Re Minor Modification
Sage
1509 North Jackson Apartments
Engberg Anderson Project No. 132251.01
EA File Name: P:\2013 2248\132251 Dominion Properties\1-Project Administration\6-Codes & Zoning\Zoning\8-13-13 Minor Modification\ 2251.01-Sage 1509 Jackson Apartments Koster 9-10-13

The following is a list of items that have been modified relative to the approved DPD, and for which the Owner will be seeking a minor modification. The numbered points below also correspond to the numbered points on the attached exhibits A through C:

EXHIBIT 'A'
8-13-13

DESCRIPTION:
PROPOSED SITE PLAN

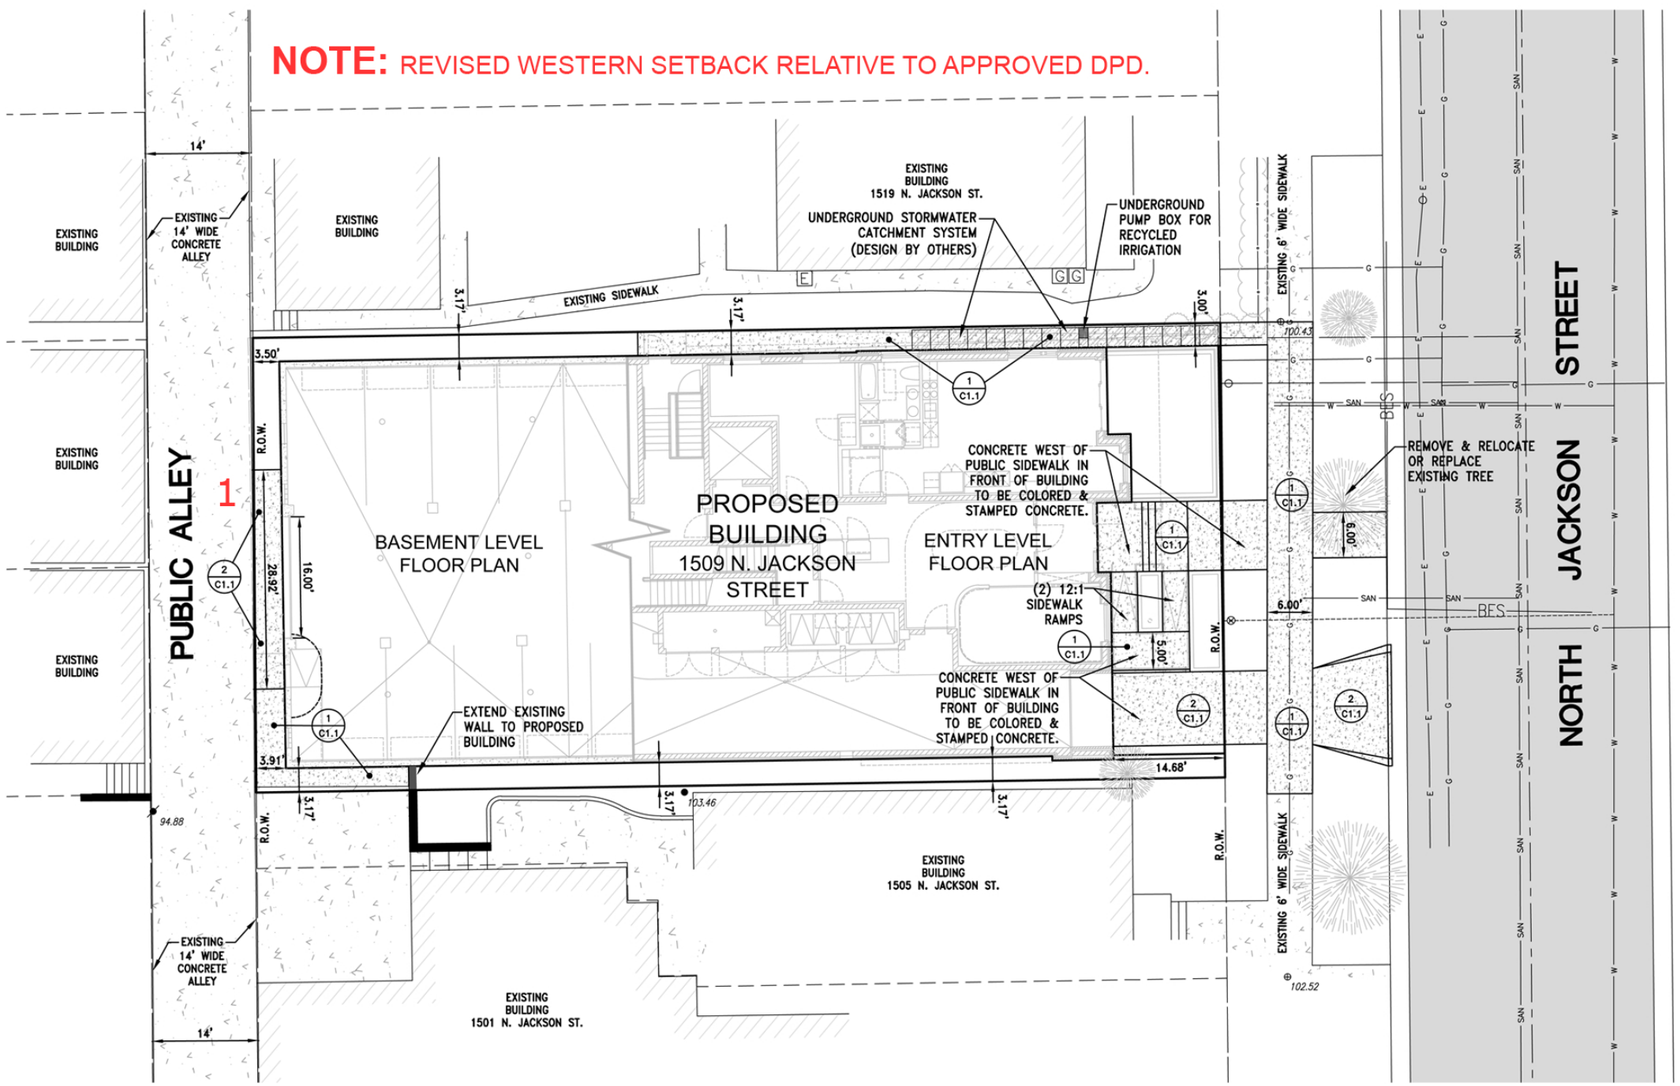
1. Rear (alley) setback was to be 4 feet per the approved DPD. Given the irregular site shape (slightly trapezoidal) the setback now ranges from 3.9 feet to 3.5 feet. (See exhibit A)

NOTE: REVISED WESTERN SETBACK RELATIVE TO APPROVED DPD.

Exterior Elevations

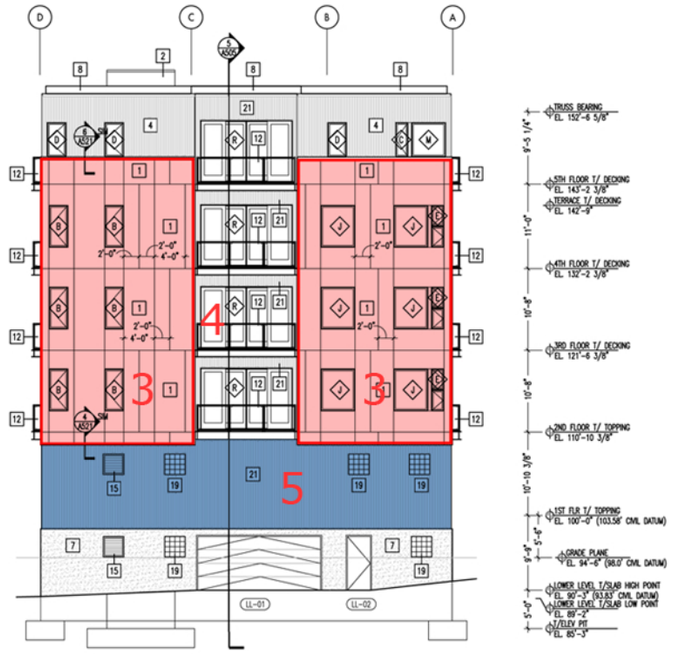
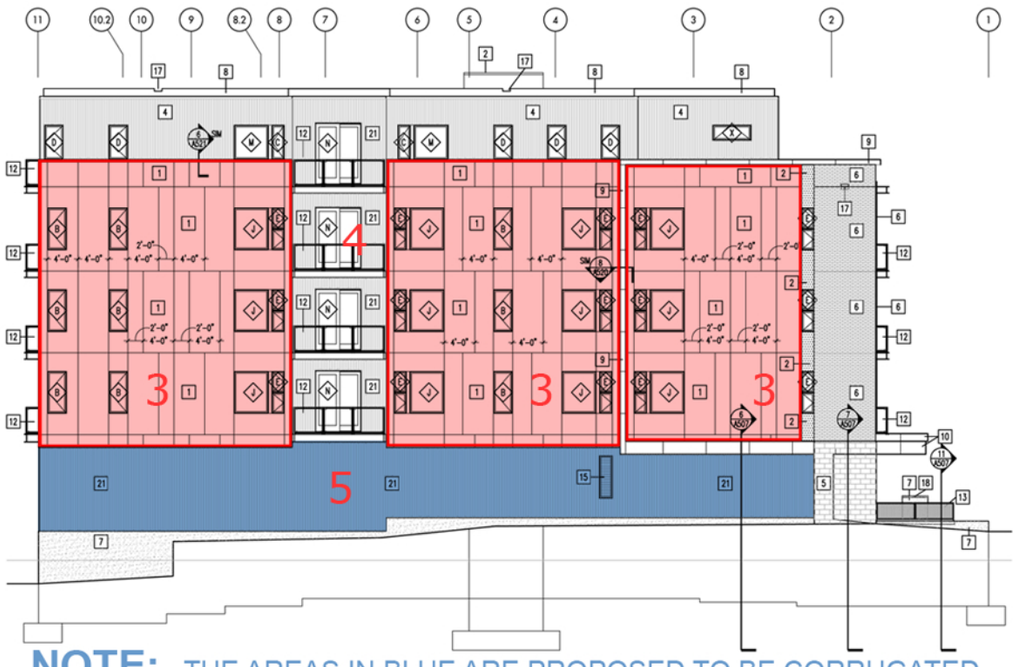
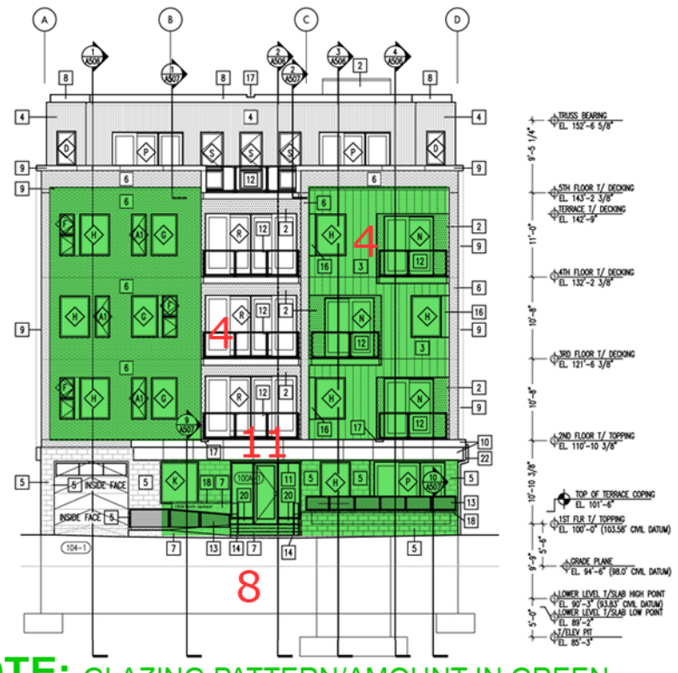
2. East (Jackson) façade windows have been reduced in size on the brick half of the building, as did the balcony glazing on the northern balconies. Window patterns on the brick portion have been slightly modified. (See exhibit B)

3. Cement panel will be used in lieu of polyaspartic coating per the approved DPD. (See exhibit B)
4. Balcony guardrails were changed to wire mesh in lieu of glass panels per the approved DPD. (See exhibit C)

5. Base material on first floor west, north and south elevations has been changed from cast in place concrete to corrugated metal panel. (See exhibit B)

6. Glass block windows along the back base of the north elevation (facing a house) have been omitted. (See exhibit B)
7. The brick wrap-around from the Jackson elevation stops about 2/3 of the way through the bay; the western most 1/3 is now fiber cement panel. (See exhibit B)

8. Entrance along Jackson Street has changed to include less glazing. (See exhibit B)
9. Typical balcony construction will be wood with a perforated aluminum soffit and aluminum fascia in lieu of perimeter steel channel as indicated on the Issued for Permit set dated 8-2-13. (See exhibit C)

10. North, south and west façade windows have been reduced in size and the pattern slightly modified relative to the approved DPD. (See exhibit B)

NOTE: THE AREAS IN RED ARE PROPOSED TO BE FIBER CEMENT PANELS WITH ALUMINUM TRIM REVEALS IN LIEU OF THE POLYASPARTIC COATING PER THE APPROVED DPD.

NOTE: THE AREAS IN BLUE ARE PROPOSED TO BE CORRUGATED METAL PANEL IN LIEU OF CIP CONCRETE PER THE APPROVED DPD.

NOTE: GLAZING PATTERN/AMOUNT IN GREEN AREAS REVISED RELATIVE TO APPROVED DPD. 2

8 A532 GUARDRAIL GR-2
SCALE: 3/4"=1'-0"

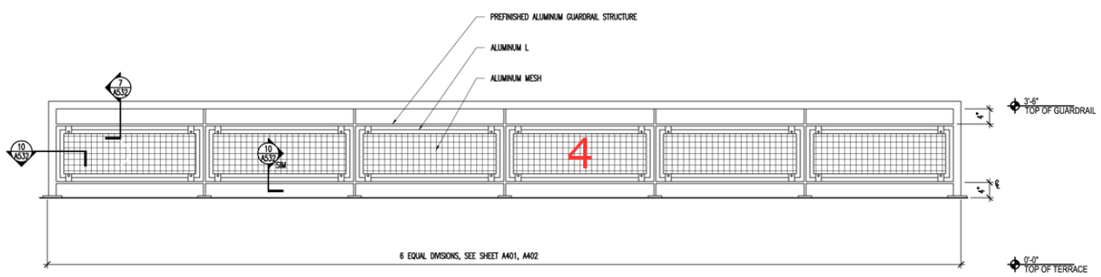
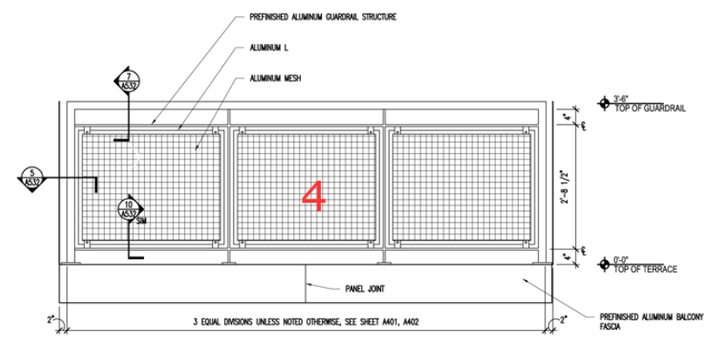
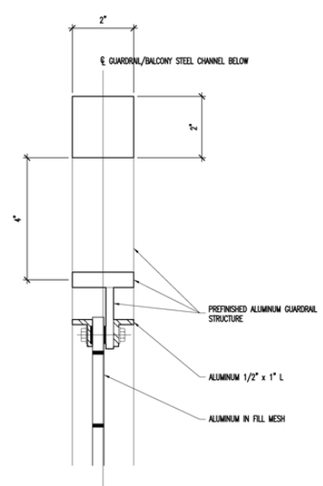
NOTE: PREFINISHED ALUMINUM GUARDRAIL WITH ALUMINUM MESH IN-FILL IN LIEU OF PAINTED STEEL GUARDRAIL WITH HEAVY GLASS IN-FILL PER APPROVED DPD.
